# CITY OF SAN ANTONIO

This is to inform you that the Preliminary Overall Area Development Plan (POADP) for Northwest Crossing (File #83-10-60-48) was jointly reviewed by Planning and Traffic Engineering staff. Said review concentrated on areas for which plats have not been approved or recorded.

**NORTHWEST CROSSING SUBDIVISION**  
PRELIMINARY OVERALL AREA DEVELOPMENT PLAN

RE: Northwest Crossing POADP  
File #23

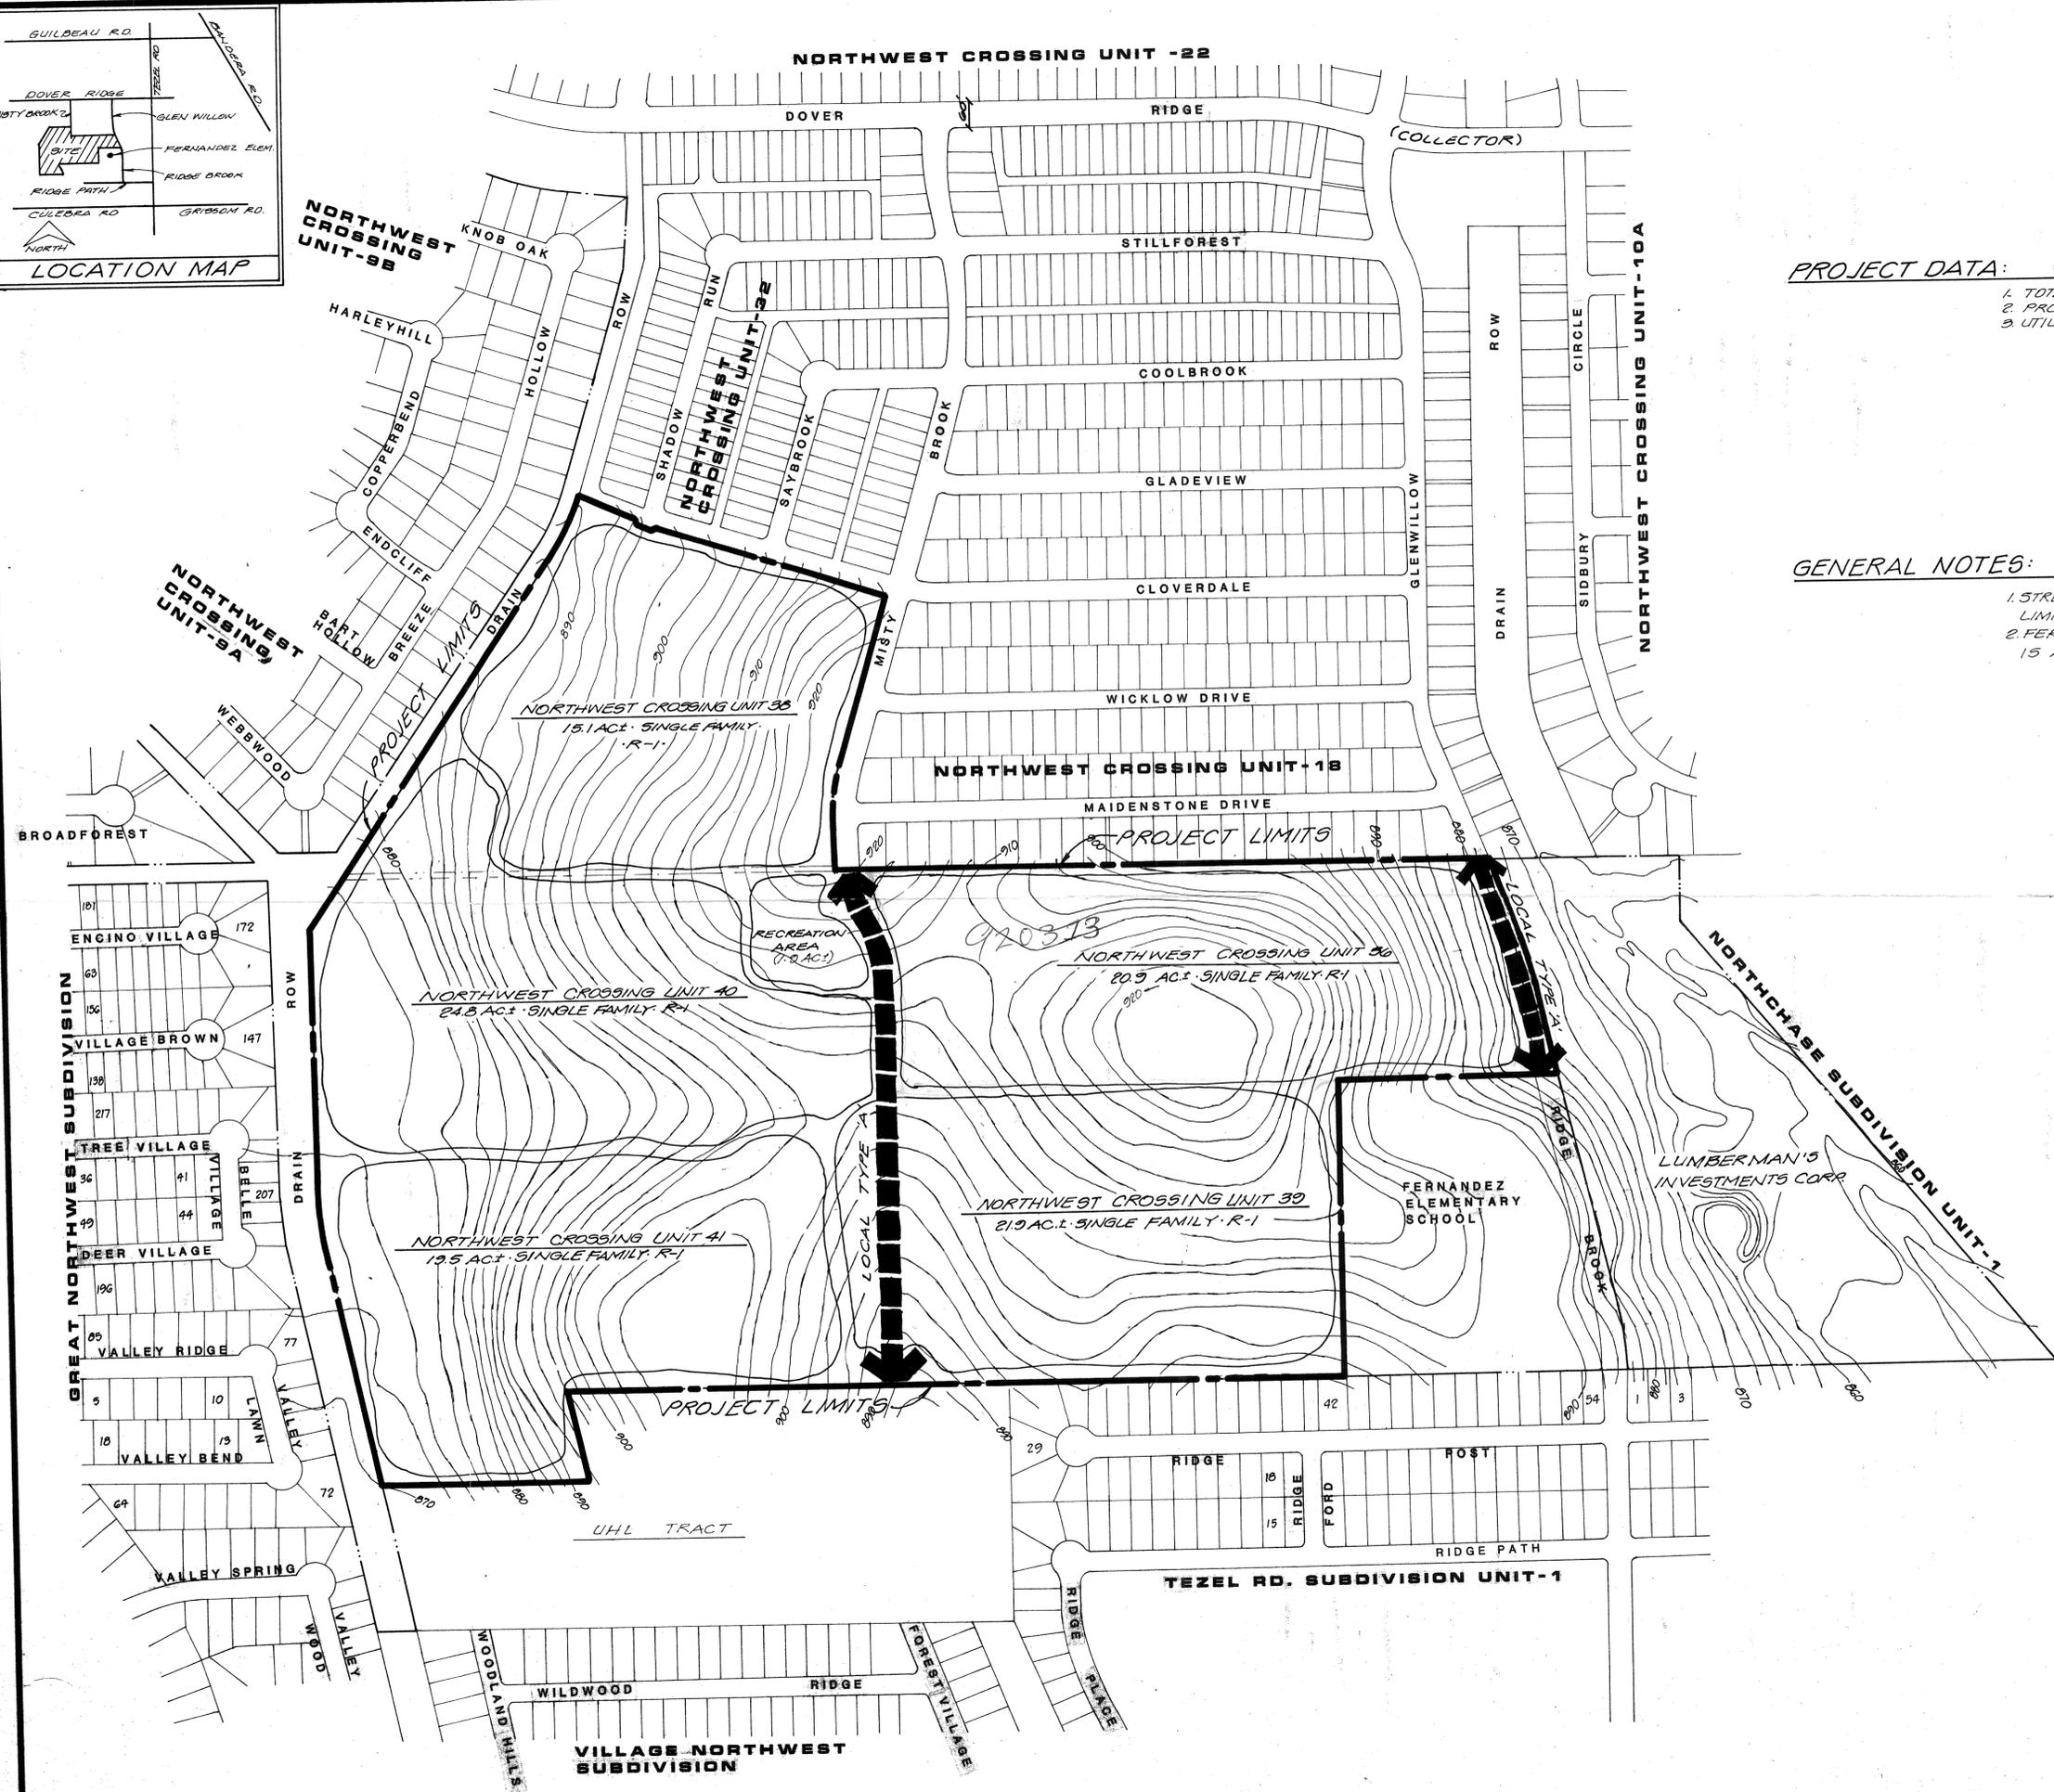
The Development Review Committee has reviewed and accepted your revised N.W. Crossing Subdivision Preliminary Overall Area Development Plan #23. An approved copy is enclosed for your files. However, the Traffic Design Engineer recommends the following:

1. Both Glenwillow and Ridge Brook are local (Type A) streets with single-family residential frontage. If these streets were connected as shown on the POADP, then both streets will likely suffer with increased traffic volumes and speeds. Therefore, it is recommended that a direct connection not be constructed.
2. The above notwithstanding, we recognize a need to provide access between the existing Fernandez Elementary School and the residential area to the north. Therefore, it is recommended that a circuitous route between these two areas be designed by the developer, and that such a design satisfactorily discourage high volume and high speed traffic on these streets.
